AI-3030-A50-B60-C100 共8套

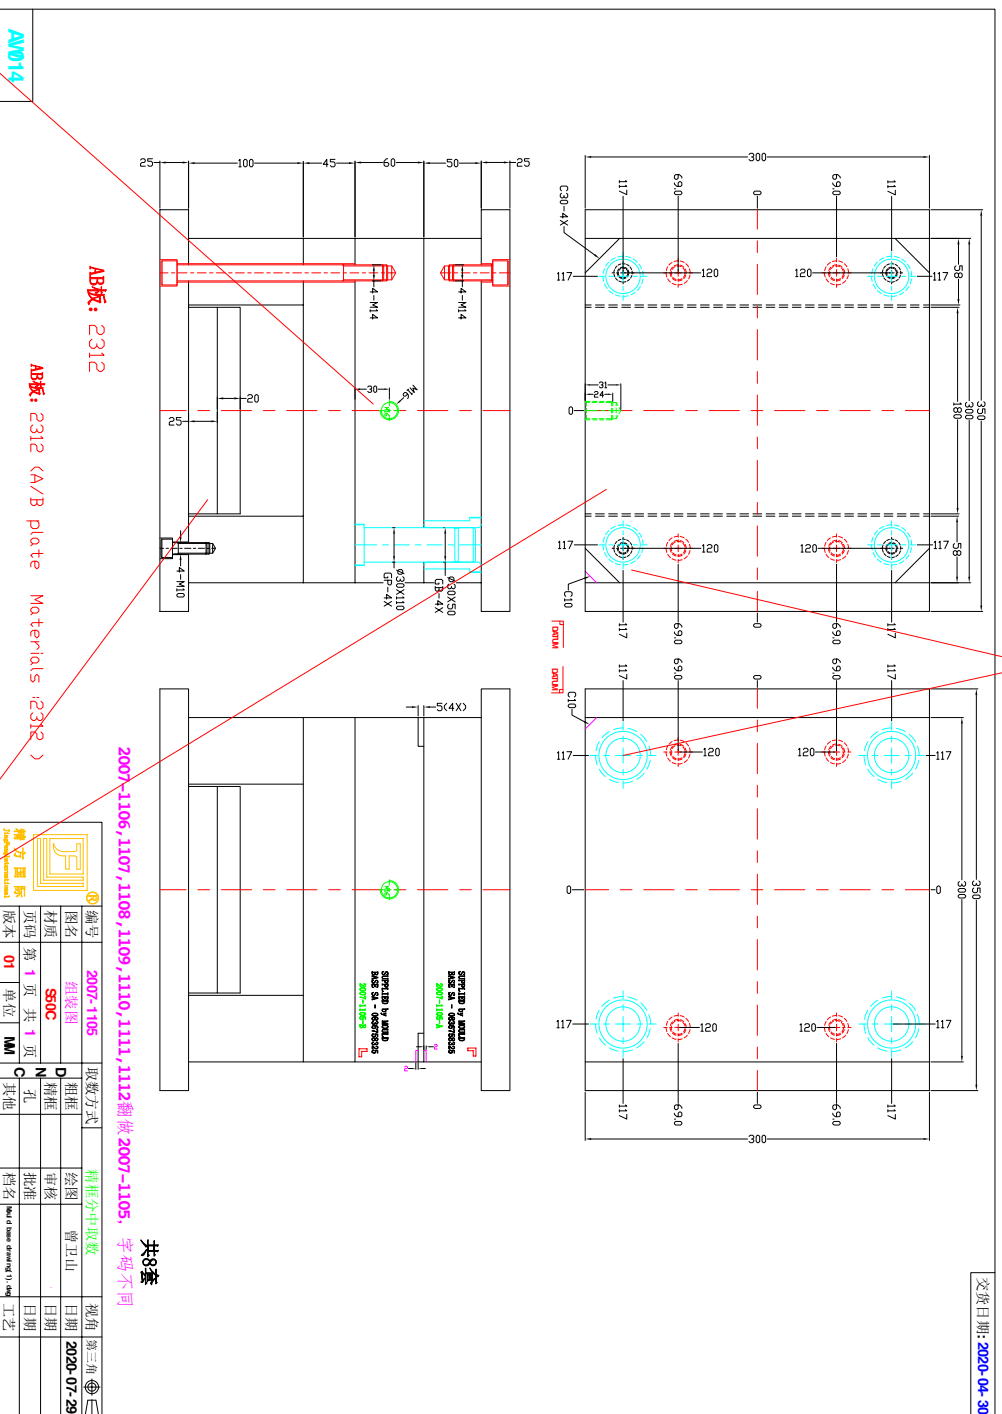
The position of the four pillars is the same .no ofset

Only need one eyebolt hole in the B Plate.

No screw holes in the ejector plate, and don't need to make return pin holes
